Access Compliance Report Public Rights-of-Way (Curb Ramps)

Main Street: SILVER_FOX_RD Cross Street: BLUME_DR Location: NE

ADA ID: RPRK211208131132 Ramp Type: Type 1 - Perpendicular Diagonal Initial Pass/Fail: Fail Overall Compliance: No Severity Score: 2

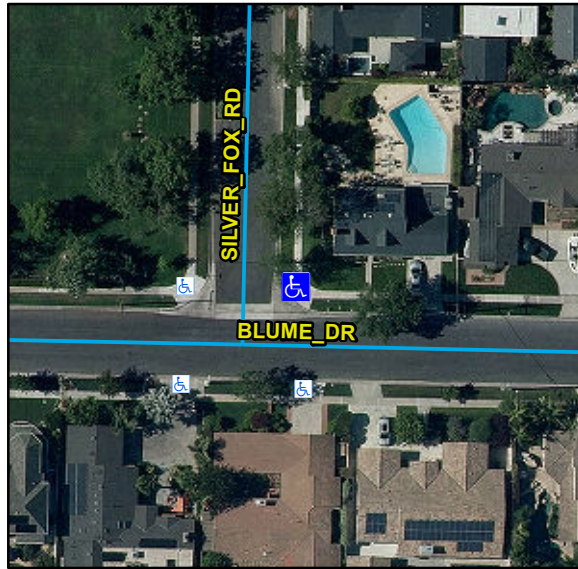
R204.3, R304.5.3, STD 1115

Compliance	Description	Data	Compliance	Description	Data
N/A	Ramp Length (in)	82	N/A	Flare Type LT	
Yes	Ramp Width (in)	48			N/A
Yes	Ramp Run Slope (%)	6.3	N/A	Flare Slope LT (%)	N/A
No	Ramp Cross Slope (%)	3.1	N/A	Flare Traversable LT	N/A
N/A	Landing Present	N/A	N/A	Flare Type RT	
N/A	Landing Length (in)	N/A			N/A
N/A	Landing Width (in)	N/A	N/A	Flare Slope RT (%)	N/A
N/A	Landing Run Slope (%)	N/A	N/A	Flare Traversable RT	N/A
N/A	Landing Cross Slope (%)	N/A	N/A	DWS Provided	N/A
N/A	Landing Movement Obstructed?	N/A	N/A	DWS Contrast	N/A
	Landing Movement Type	N/A	N/A	DWS Length (in)	N/A
N/A	Landing Shared	N/A	N/A	DWS Full Width	N/A
N/A	Clear Space	Yes	N/A	DWS Offset Left (in)	N/A
N/A	Clear Space To Crosswalk (in)	N/A	N/A	DWS Offset Right (in)	N/A
N/A	Marked Crosswalk 1	No	N/A	Marked Crosswalk 2	No
	Crossing 1 Direction	W		Crossing 2 Direction	S
	Marked Crosswalk 1 Width (in)	N/A		Marked Crosswalk 2 Width (in)	N/A

Remove & Replace Curb Ramp With Two New Directional Ramps or Equivalent.
